PRFUP20251237

City of Puyallup
Development & Permitting Services
ISSUED PERMIT

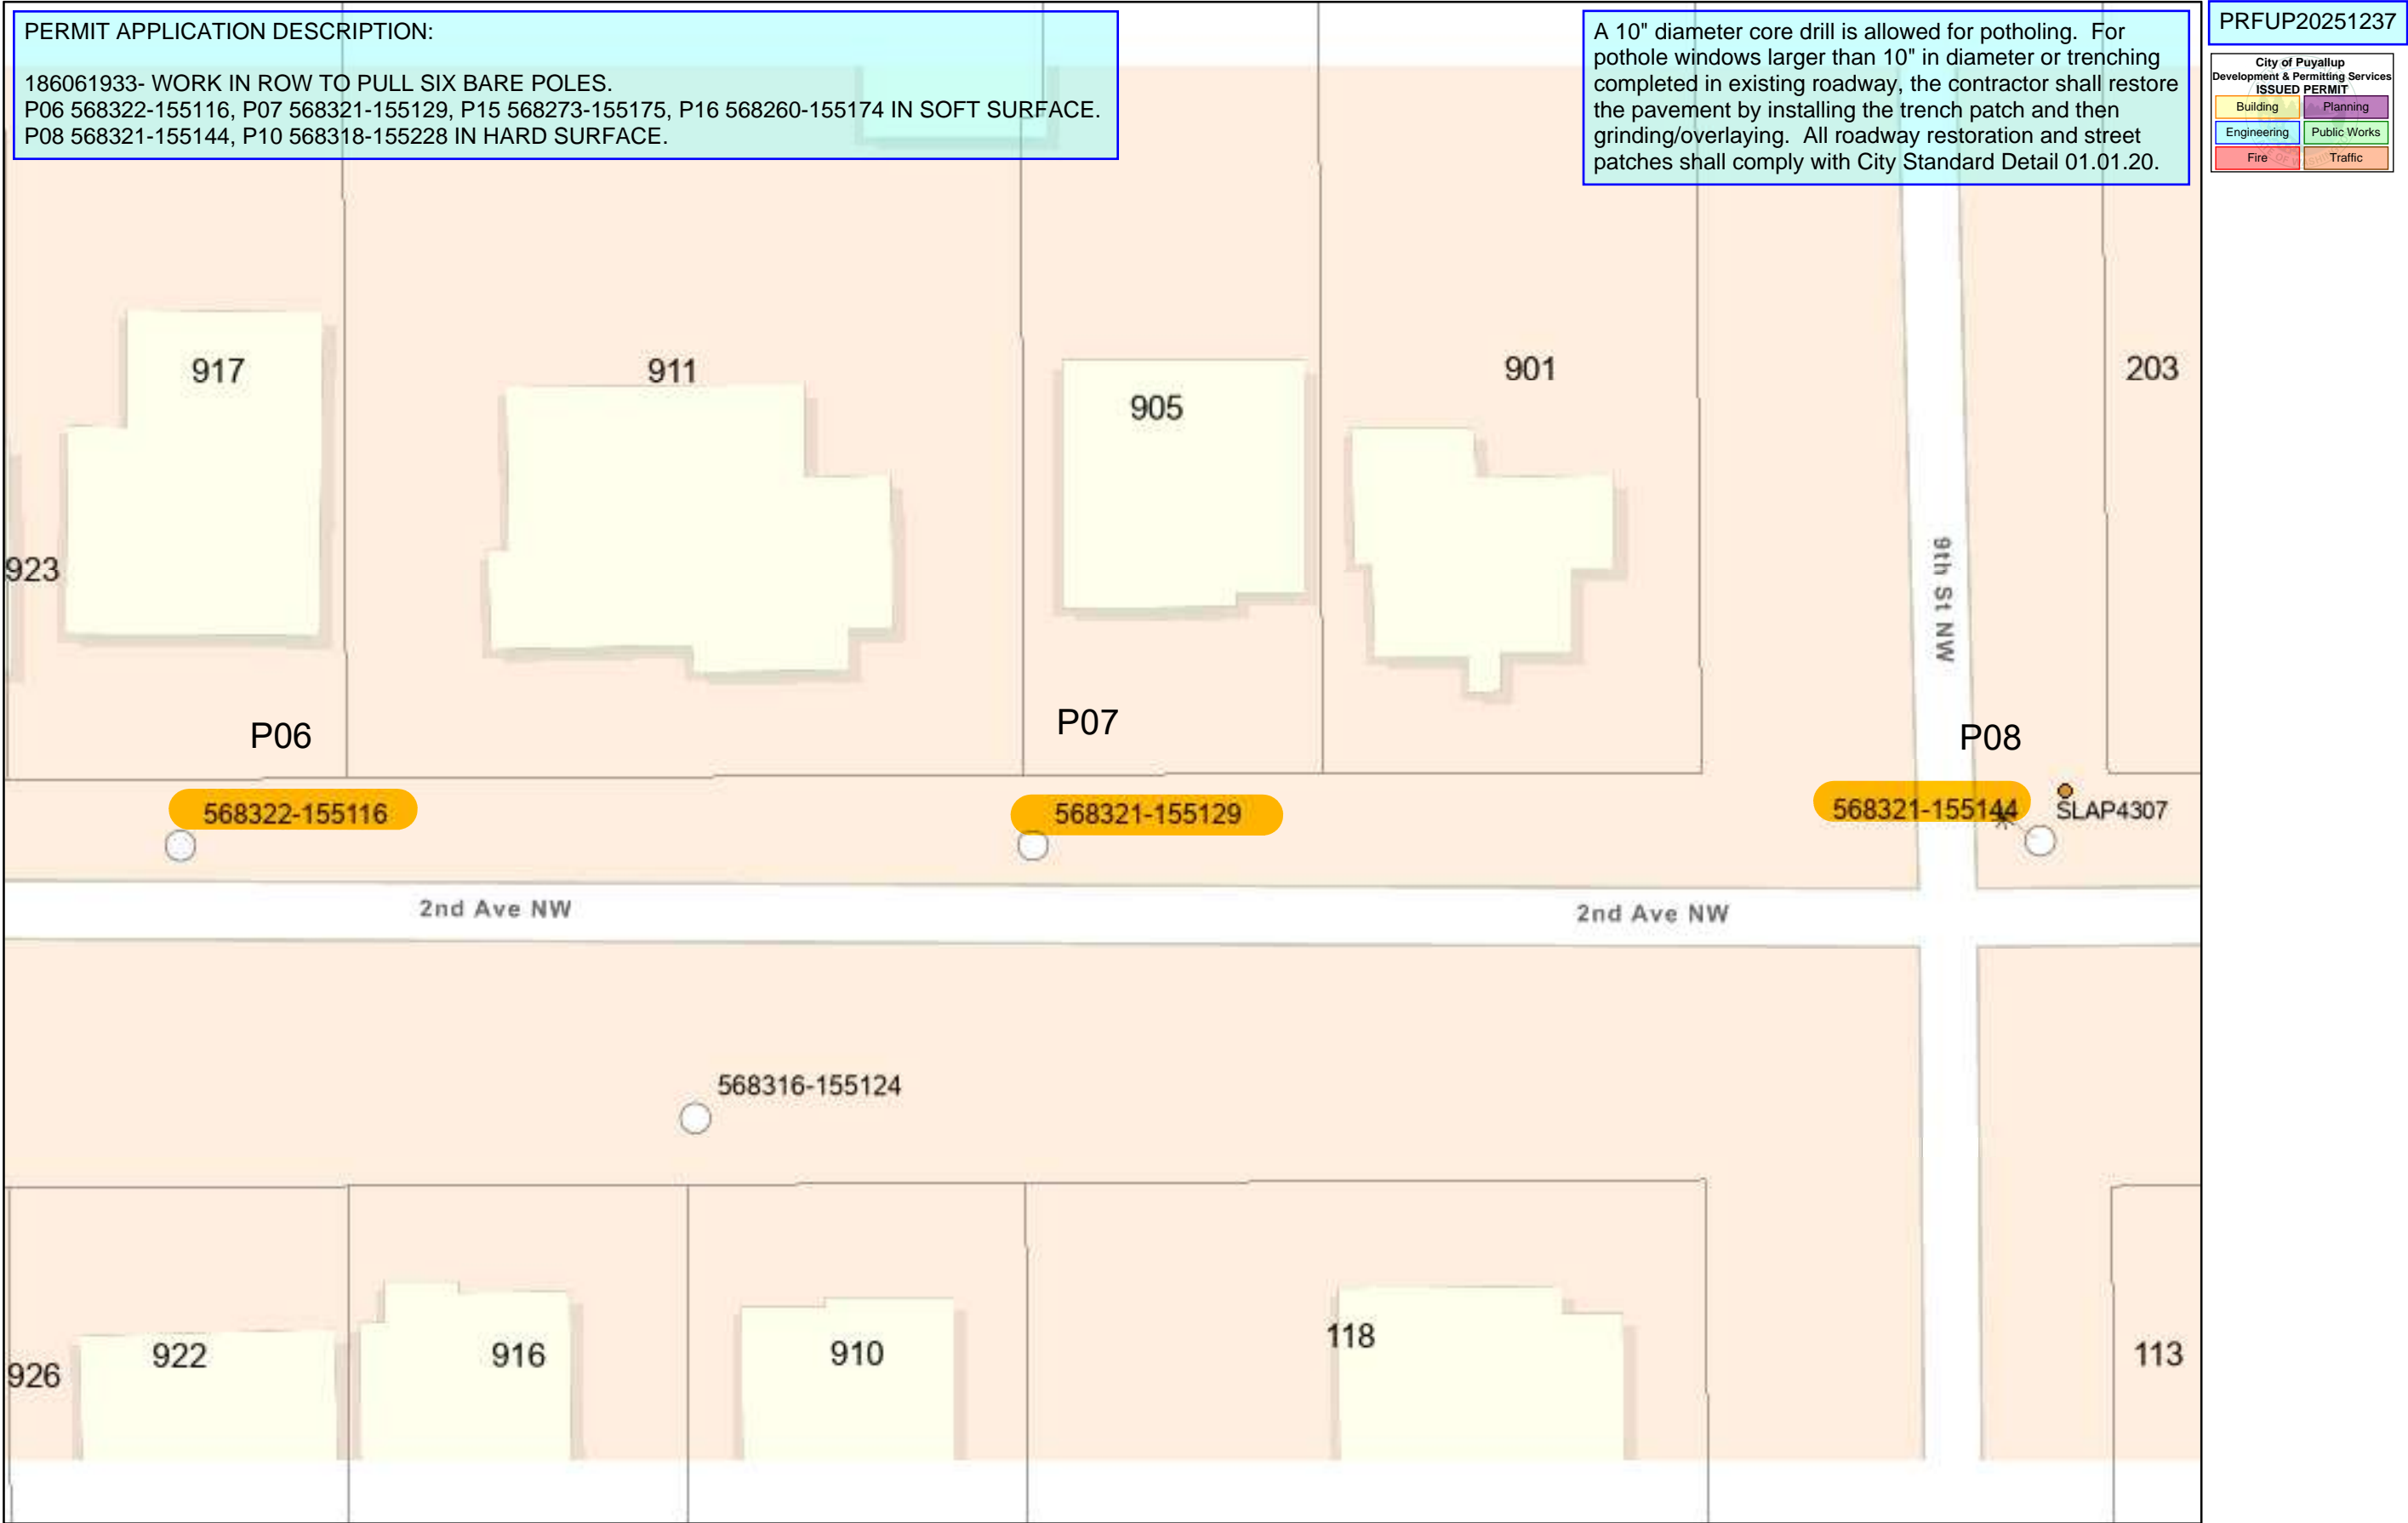
A 10" diameter core drill is allowed for potholing. For pothole windows larger than 10" in diameter or trenching completed in existing roadway, the contractor shall restore the pavement by installing the trench patch and then grinding/overlaying. All roadway restoration and street patches shall comply with City Standard Detail 01.01.20.

Under right-of-way permit PRROW20241104, the Puyallup School District has temporarily closed the portion of 7TH ST SW between 3RD AVE NW and W MAIN. The applicant may need to coordinate access to utility pole P10 with the School District in advance. The road closure and the School's right-of-way permit do not negate any permit conditions, standards, or traffic control plans for franchise permit PRFUP20251237.

A 10" diameter core drill is allowed for potholing. For pothole windows larger than 10" in diameter or trenching completed in existing roadway, the contractor shall restore the pavement by installing the trench patch and then grinding/overlaying. All roadway restoration and street patches shall comply with City Standard Detail 01.01.20.
